**RE: State Significant Development Application SSD 8378**

**PROPERTY: C The Hermitage Way, Gledswood Hills  
Lot: 3, DP: 1227491**

## Submission on Proposed Gledswood Hills Primary School – Key Issues

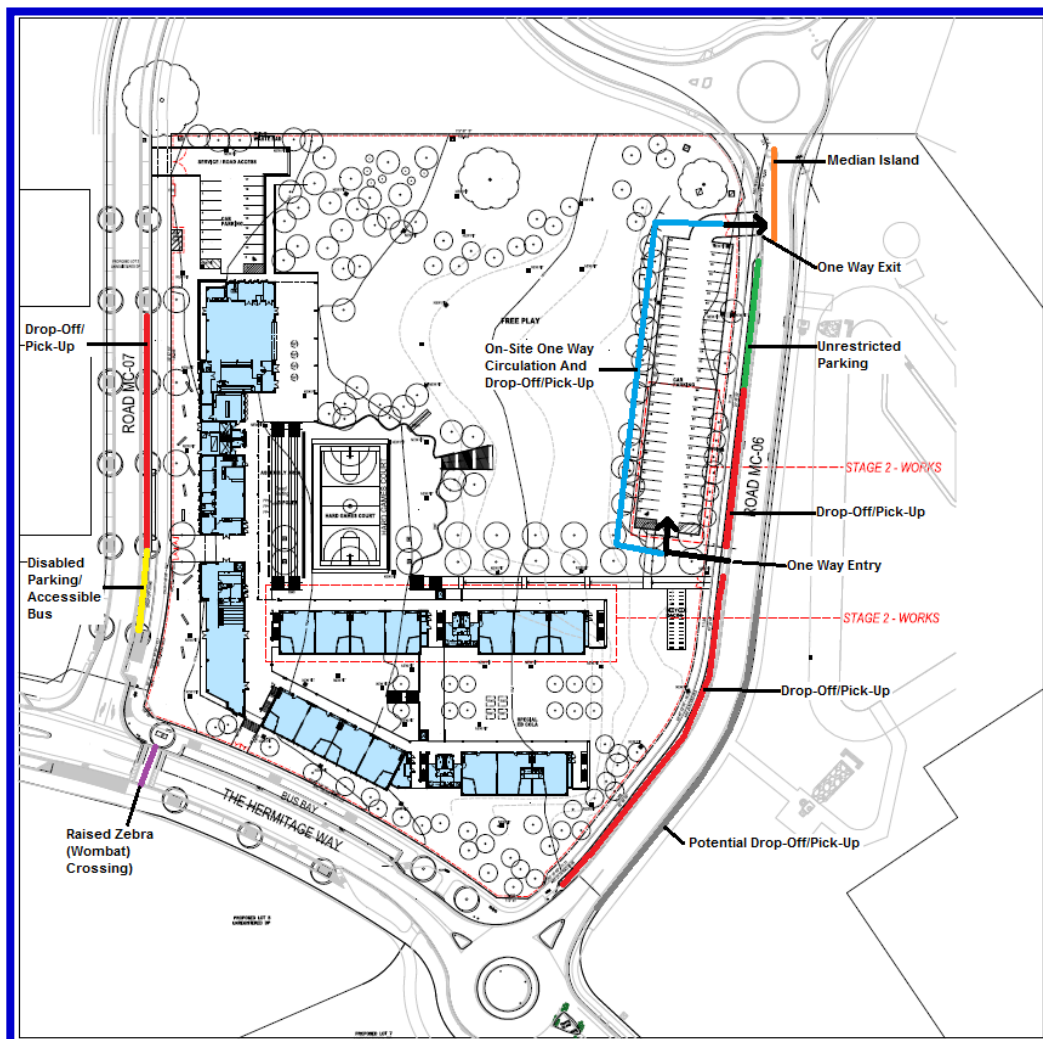
It is recommended that an off-street drop-off/pick-up area, including a one-way travel lane, is provided behind the car park off road MC-07. A pedestrian path should connect this area to the main pedestrian travel path through the site. The access to this car park should be modified to incorporate a one way entry/exit arrangement to facilitate the new drop-off/pick-up area.

Consequently it is recommended that an additional on street drop-off/pick-up area is formalised along road MC-07 to provide additional capacity nearer to the school buildings. It is also recommended to convert some of the drop-off/pick up area on road MC-06 past the pedestrian entry/exit gates to unrestricted parking.

- The proposed accessible bus parking area on road MC-07 should be modified to be a general disabled car parking area that is available for both the accessible bus and disabled car parking. The accessible bus parking times should be staggered to ensure they do not conflict with general disabled parking for the school.

- A median island should be provided in front of the access to the car park on road MC-06 and adjacent to the future roundabout to the north. The purpose of this is to ensure that vehicle movements into and out of this car park are restricted to left in/left out only.
- The existing speed hump on The Hermitage Way frontage should be converted to a raised zebra (wombat) crossing.

The above amendments are shown in the marked-up plan below:

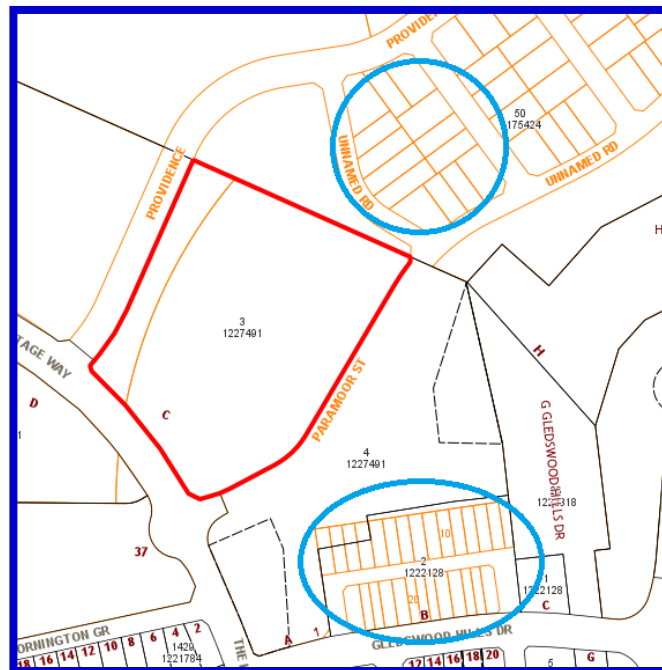
1. An additional acoustic assessment, prepared in accordance with Council's Environmental Noise Policy, must be completed to assess the potential noise impacts upon two proposed nearby residential developments (locations circled in blue on the plan below). The additional assessment must also include recommendations for any required noise mitigation measures.
